## QUALITY ASSURANCE -- NON-CONFORMANCE REPORT

**Report No:** NCR-000805

**Reference Description:** Segment 7BW Floorbeam & Bottom Panel at the FL3 area was damaged during its loading onto the ship

**Subject:** NCR No. ZPMC-0767

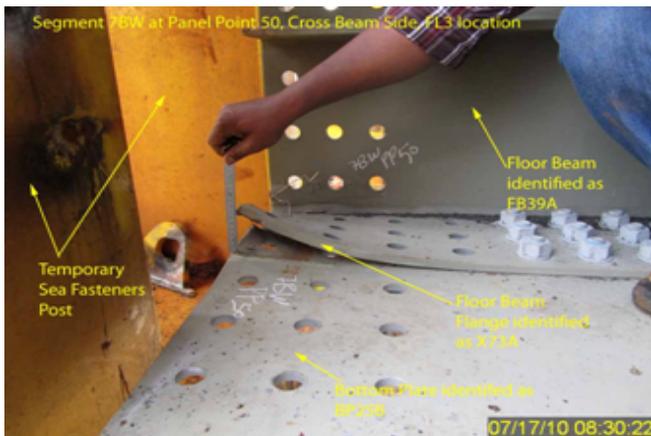
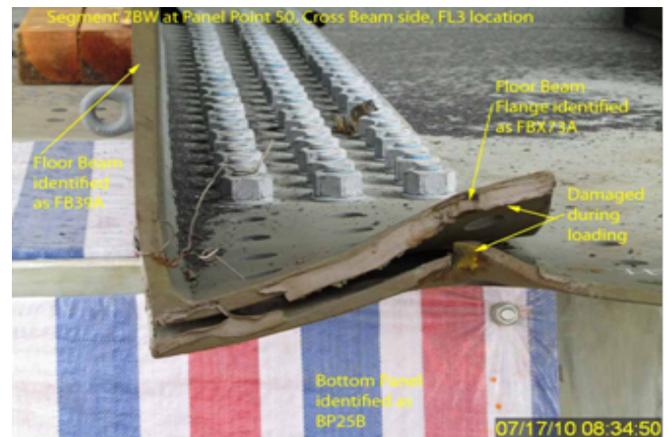
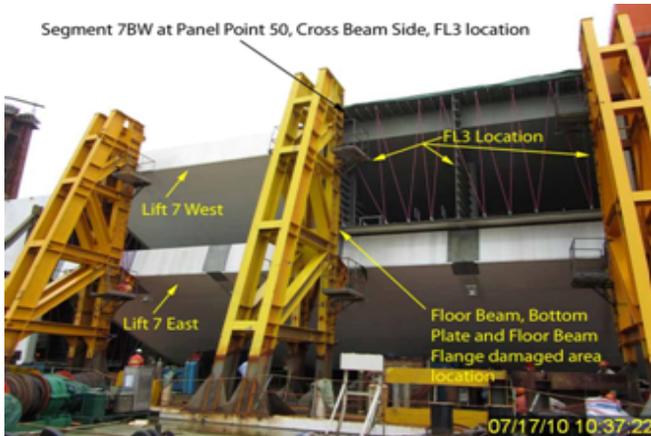
- Segment 7BW was damaged during its loading onto the ship. The damage areas were at the lower portion of the Floor Beam, the adjacent Floor Beam Bottom Flange, and the adjacent Bottom Panel at the FL3 Location. The measured maximum bent is at the Bottom Panel near the Crossbeam connection at Panel Point 50. The skin is out of flatness with a maximum deflection of 70mm when measured with 630mm Straight Edge.
- The FL3 location Floor Beam identified as FB39A.
- The Floor Beam Web identified as X90A.
- The Floor Beam Flange identified as X73A.
- The Bottom Plate identified as BP25B.
- Segment 7BW is located on Ship Zhenhua #19.

ZPMC has repaired the areas documented in the NCR and is providing NDT documents to show that it is acceptable. ZPMC QA has written an internal NCR to the handling department to ensure that this is prevented in future occurrences. Based on this ZPMC request closure of this NCR.

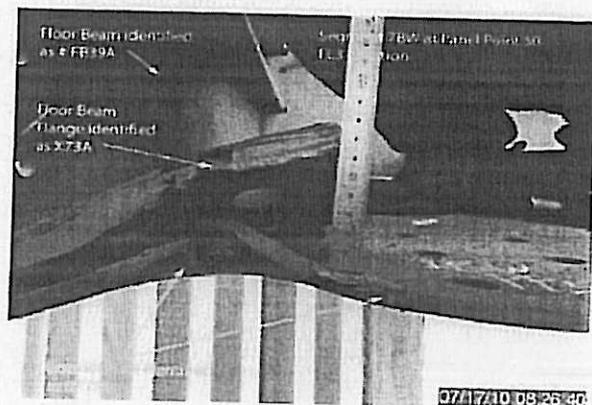
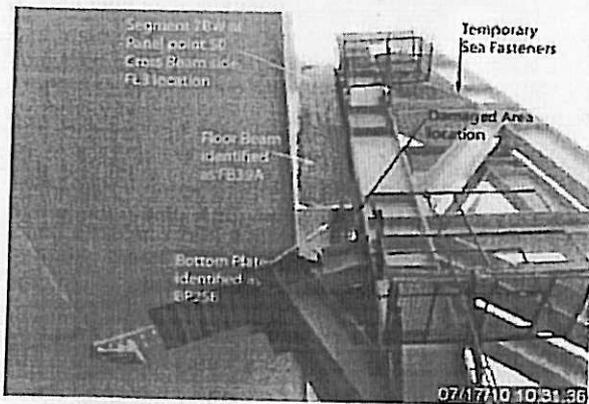
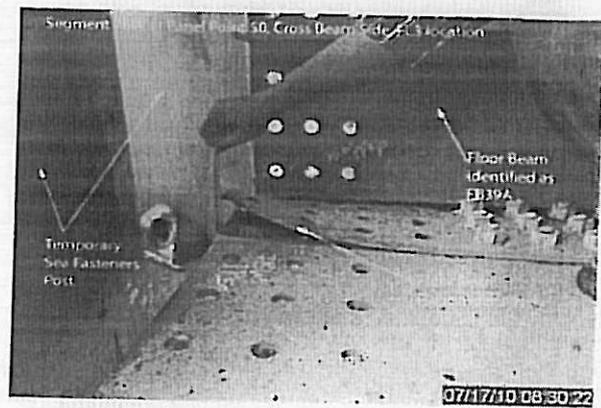
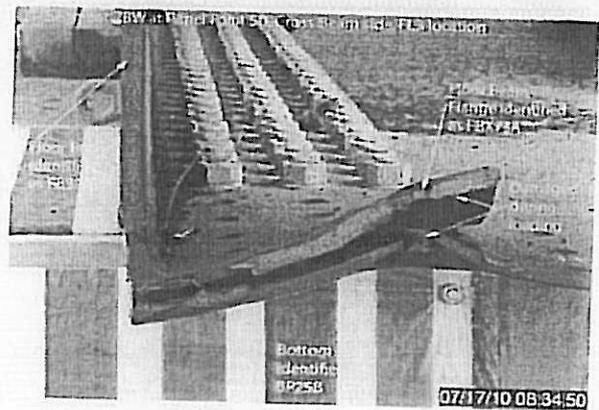
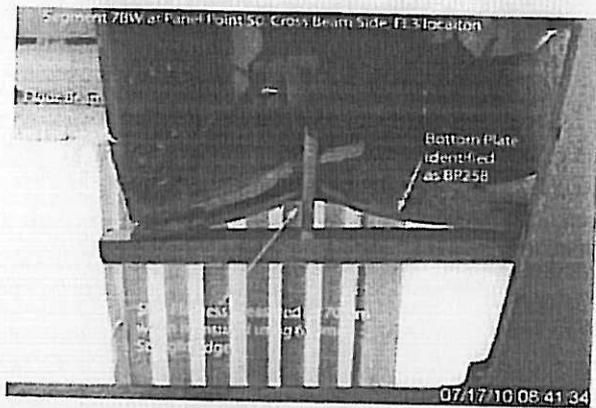
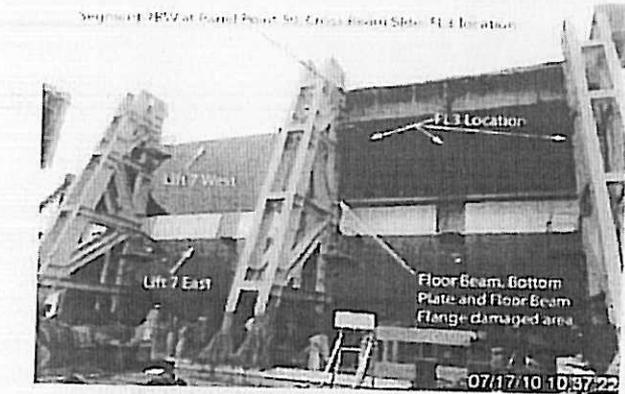
- Segment 7BW was damaged during its loading onto the ship. The damage areas were at the lower portion of the Floor Beam, the adjacent Floor Beam Bottom Flange, and the adjacent Bottom Panel at the FL3 Location. The measured maximum bent is at the Bottom Panel near the Crossbeam connection at Panel Point 50. The skin is out of flatness with a maximum deflection of 70mm when measured with 630mm Straight Edge.
- The FL3 location Floor Beam identified as FB39A.
- The Floor Beam Web identified as X90A.
- The Floor Beam Flange identified as X73A.
- The Bottom Plate identified as BP25B.
- Segment 7BW is located on Ship Zhenhua #19.

Damaged areas were removed and replaced. Contractor has submitted post repair NDT documentation verifying newly added welds conform with Contract weld quality requirements. Weld maps and as-built plans will be updated to show new welds.
